DEVIATION REQUEST AND DECISION FORM

Project Name : Crawford Apartments

A deviation from the standards of or in Section 2.3.7.E.2 of the Engineering Criteria Manual (ECM) is requested.

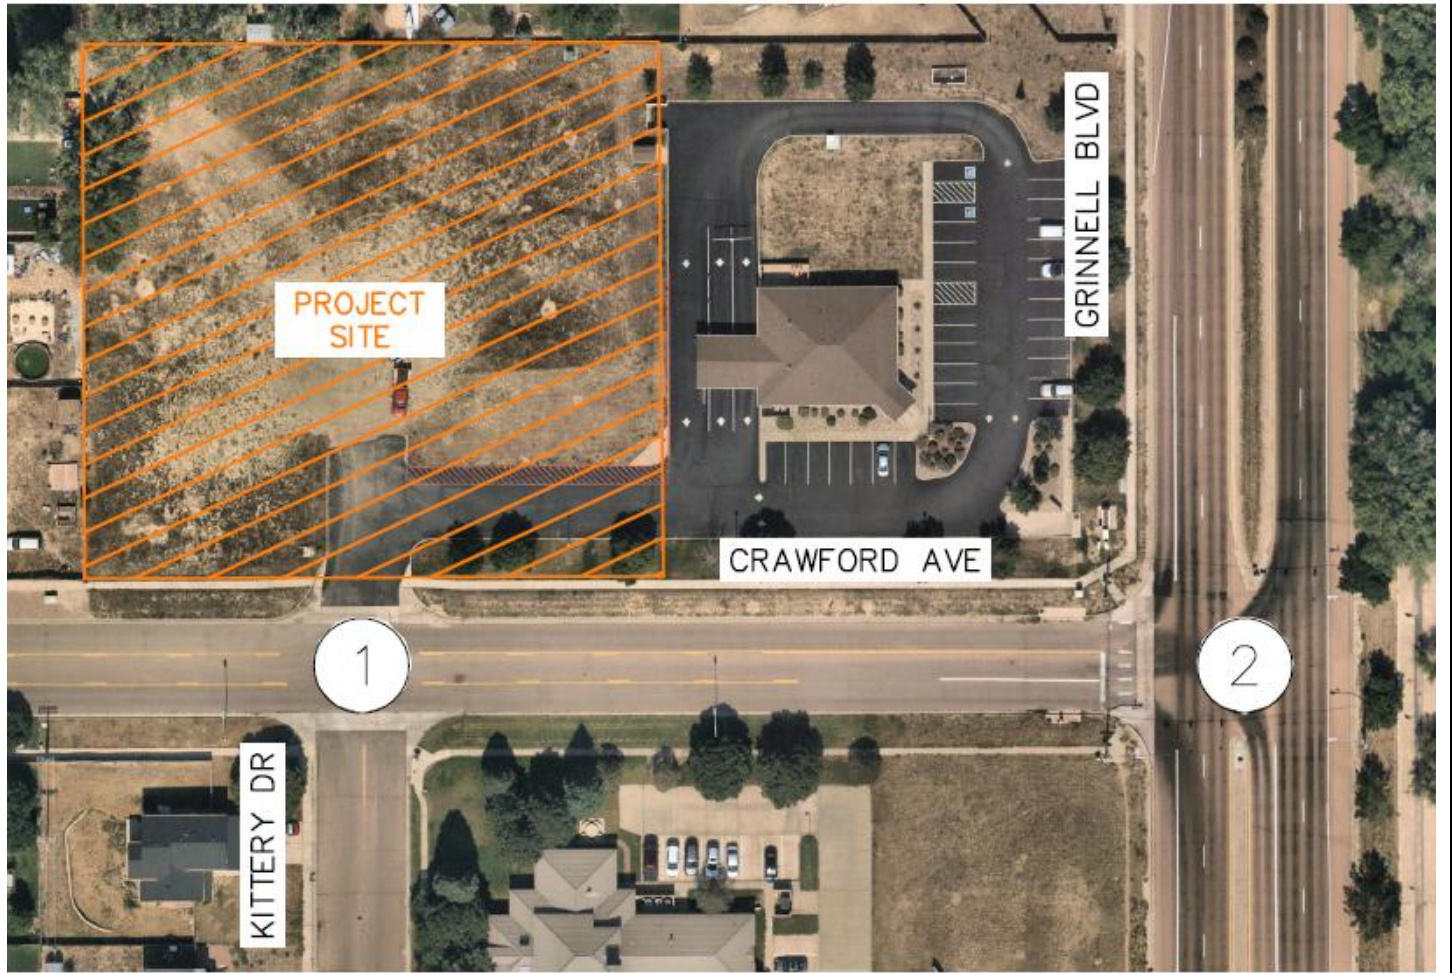
The deviation is requested to provide a substandard left turn lane at the northbound approach of the Crawford Avenue and Grinnell Boulevard intersection (Intersection #2) (see traffic study and image below for reference).

To meet El Paso County standards for a design speed of 55 mph, the recommended northbound left turn lane at the intersection of Crawford Avenue and Grinnell Boulevard should provide 265 feet of deceleration length (ECM Table 2-26) plus 100 feet of storage length (determined from ECM Table 2-30 for each location) plus a 220-foot taper (ECM Table 2-26). Since vehicle queues are only calculated with under 50 feet of storage and to avoid reconstructing the existing raised median for only an additional 65 feet of length, it is recommended that the existing median for the northbound left turn lane at Crawford Avenue and Grinnell Boulevard intersection remain in the current condition of 300 feet with a 220-foot taper.
